THE CEDAR VALLEY COMMUNITIES

REGIONAL URBAN DESIGN ASSISTANCE TEAM

WATERLOO
CEDAR FALLS
BLACKHAWK COUNTY

R/UDAT REPORT

D. O.T. Section at Magnolia Dr.

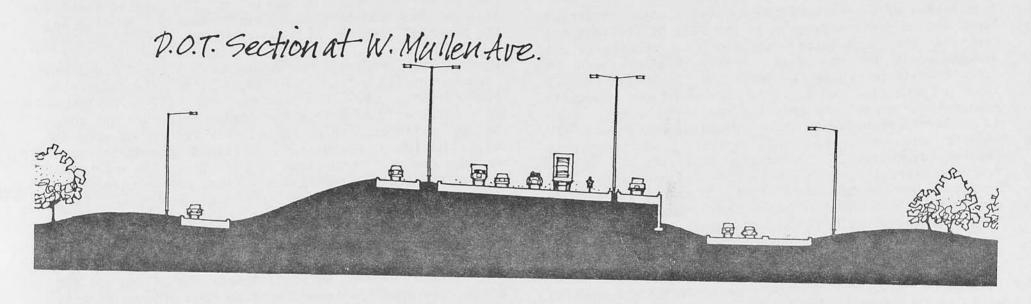
Redesign the 218 corridor as an extension of the existing open space system, particularly the Chain of Lakes. The corridor should be a scenic parkway with is own identity.

- ♦ The parkway design should reflect the specific context through which it passes. For example, the Rectilinear Street and Block of the CBD differs from curvilinear form of the John Deer property. The corridor varies in width and the design will vary; the design should reflect the unique qualities of each area through which it passes.

- Maximize opportunities for landscaping.
- Design the Parkway to capture and frame views of landscaped area and significant buildings and building complexes.

- Minimize the barrier effect of a major traffic artery. Emphasize important cross streets in the design (4th Street, for example), so that east-west communication is enhanced by the Parkway design.

- ♦ Create a condition where initial capital costs are reduced. Cut costs to a degree that the benefits of doing so adequately covers those of re-engineering and interest inflation on the construction. Realize the net worth created by the quality of life enhancements that are achieved in the form of increased marketability, economic development and public good will.

D.O.T. Section at 4.4.63

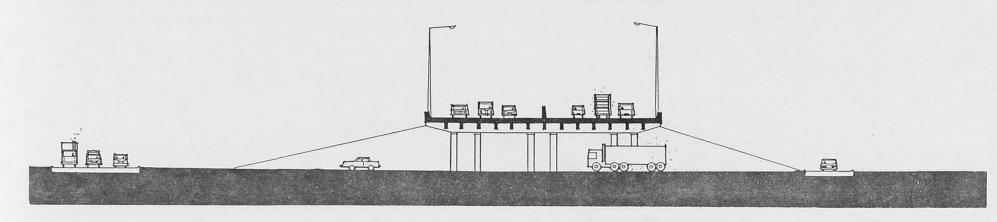
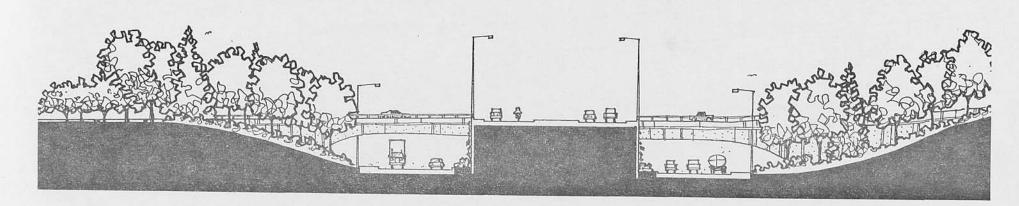
By minimizing the number of vertical curves along the corridor more visible green spaces can be developed. The visible intrusion (vertically) can be significantly reduced, roadway drainage can be more easily accommodated, green space can be planted, ponds created, etc. At grade or near at grade conditions can be accommodated along a significant portion of the remaining unconstructed section.

In combination with reducing the profile grade the horizontal alignment within the right of way can be modified to more easily expand and contract the median width. By varying the median a more curvilinear alignment can be achieved providing greater aesthetics. In addition, horizontal alignment adjustments can be used to minimize impacts on adjacent properties. Adjustments to the horizontal alignment on the remaining section can be effected along most of corridor.

D.O.T. Section at Cleveland Ave.

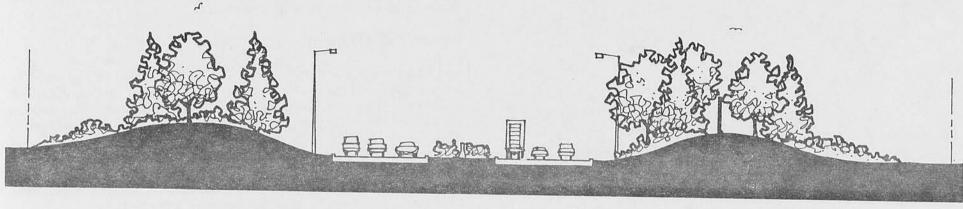
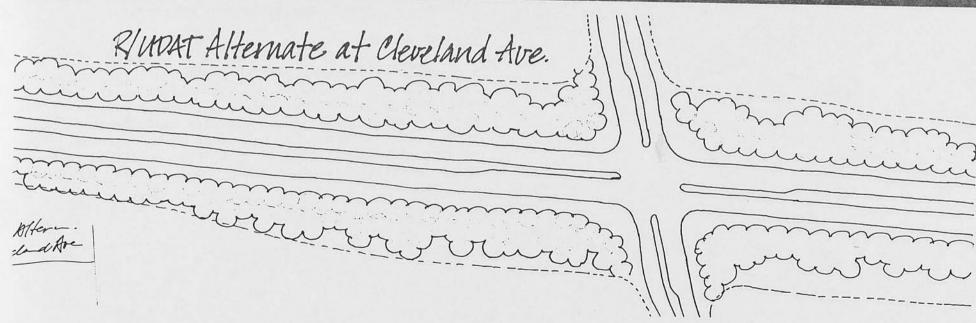
A thorough review of recent socio-economic (SE) data, SE trends for the area, and its effect on the traffic assignments, plus a review of the level of service (LOS) analysis using 1985 Highway Capacity Manual methods, may result in a decrease in the number of lanes required to achieve an acceptable LOS on the facility. In most major metropolitan areas a LOS D under urban conditions

is acceptable. By reducing the number of lanes required, the cross section is reduced. A reduced cross section allows more room for green space and mitigates residential and business impacts. In addition to laneage changes, an urban parkway can be developed with either a rural or urban section (open drainage vs curb and gutter). Changing the section properties will allow one to change the section width.

D.O.T. Section at Rainbow Dr.

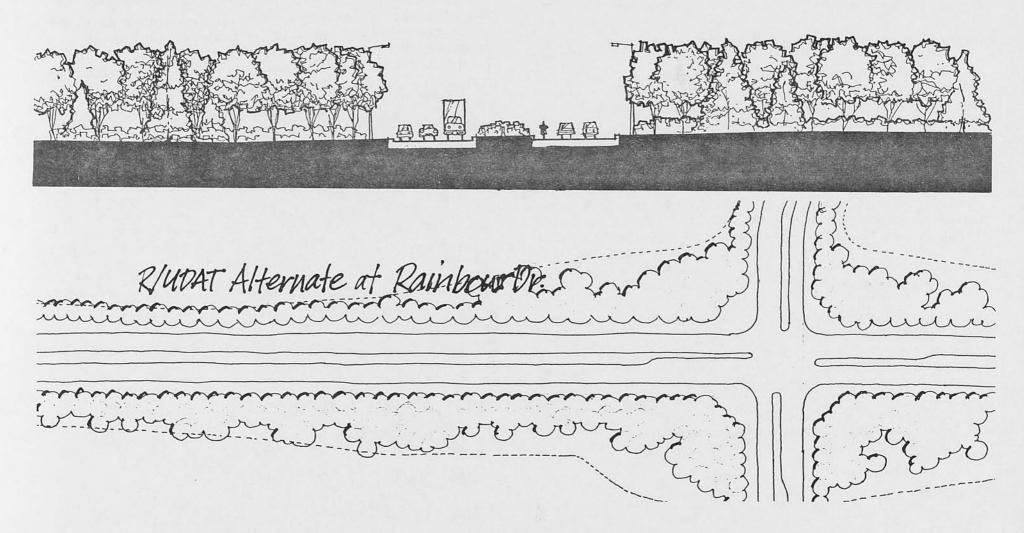
Parkway conditions allow for greater opportunities to alternate the slope treatment away from the edge of pavement. With either a rural or urban cross section the clear zone can be reduced (lower design speed, lower functional classification). By reducing the clear zone, more right of way is available for treatment.
